31 May 2022 Delivered by email

Ref: COVR3001

SDNP/21/04848/FUL: LISS FOREST NURSERY, PETERSFIELD ROAD, GREATHAM, LISS, GU33 6HA – REVISED SUBMISSION DOCUMENTS AND RESPONSE TO CASE OFFICER COMMENTS

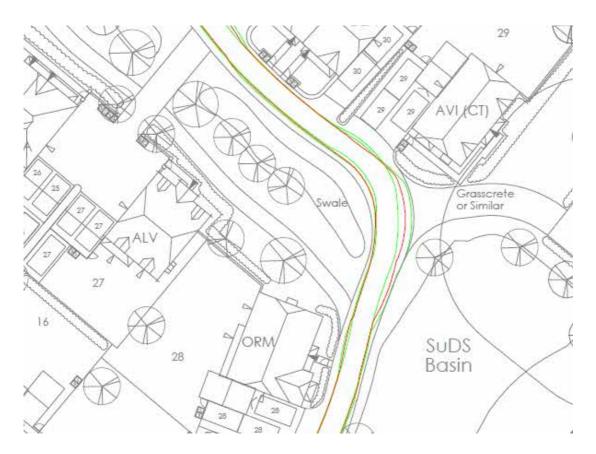
In order to accommodate Electric Vehicle Charging Points (EVCPs) to all plots the parking spaces for Plots 5, 6, 31, 33, 36 and 37 have been moved slightly forward.

In your response to the Design and Landscape Rebuttal you suggested incorporating an additional build out into the road at the swale that is opposite Plot 29. Our highways consultant has assessed the feasibility of this by reviewing vehicle tracking for larger vehicles such as refuse collection lorries. They have concluded that a build out cannot be accommodated in this location due to the proximity of the bend as shown in the extract of the vehicle tracking drawing below.
